Re: CPUC Approval of PG&E Minor Project Refinement 1 for the Manning 500/230 kV Substation Project

Manning 500/230 kV Substation Project PG&E MPR-1 Form

Manning 500/230 Kilovolt Substation Project CPUC Minor Project Refinement (MPR) Form

Map 1: Map of the existing and proposed staging area locations, with the photo point identified.

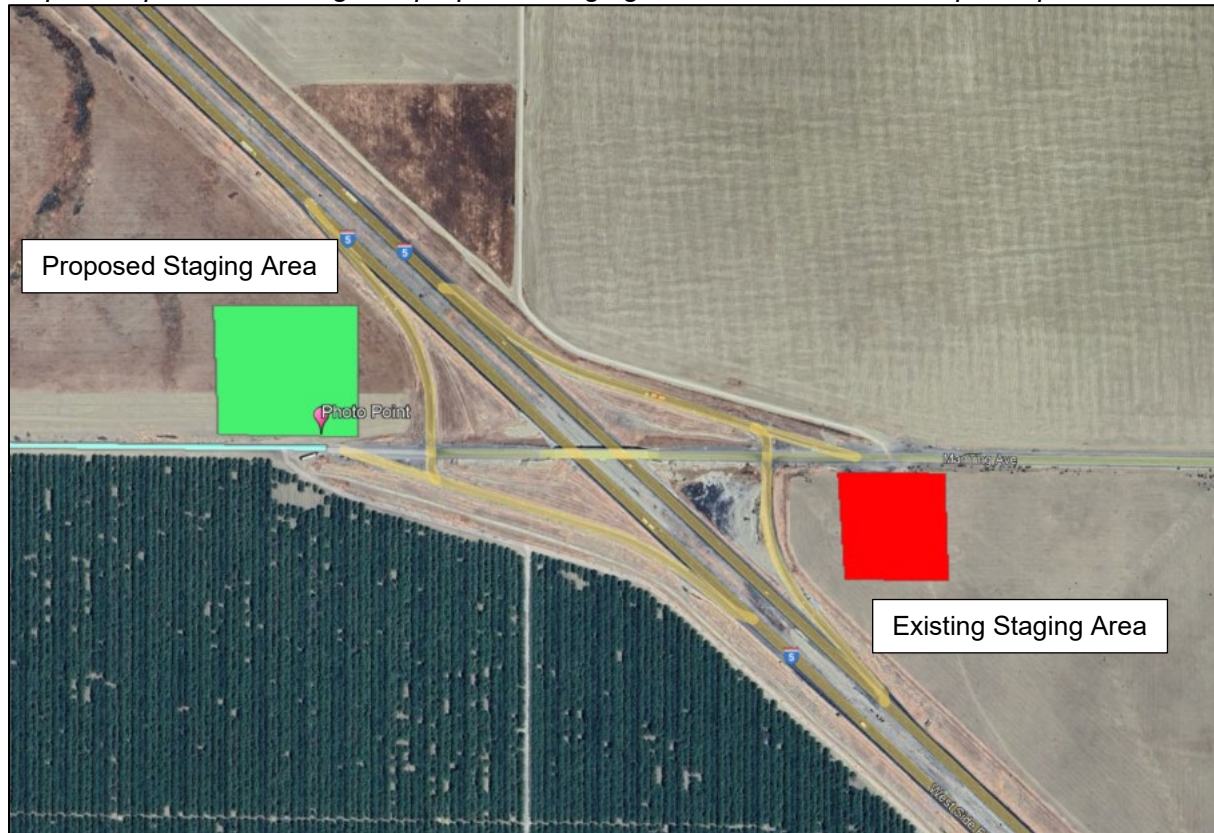
PG&E proposes to relocate the Manning Avenue staging area to the north-west corner of the intersection of Manning Avenue and Interstate-5. This area was originally identified and analyzed in the draft IS/MND. No changes are necessary to Section 2.8.2 and Table 2-6 of the final IS/MND.

Map 2 of 15 of the Vegetation Communities, Drainages and Land Cover Types mapping incorrectly identifies this parcel as largely *Amsinckia*, with a small section of Disturbed land cover. Based on field verifications in August 2025, this entire parcel should be mapped as Agricultural. Please see the photos below.

The staging area location on the south-east corner of Manning Avenue and Interstate-5 contained *Amsinckia* landcover (as of August 2025) which could potentially be habitat for listed species, including the blunt-nosed leopard lizard. Relocating the staging area to an area of existing agricultural disturbance avoids the potential for impacts to blunt-nosed leopard lizard habitat.
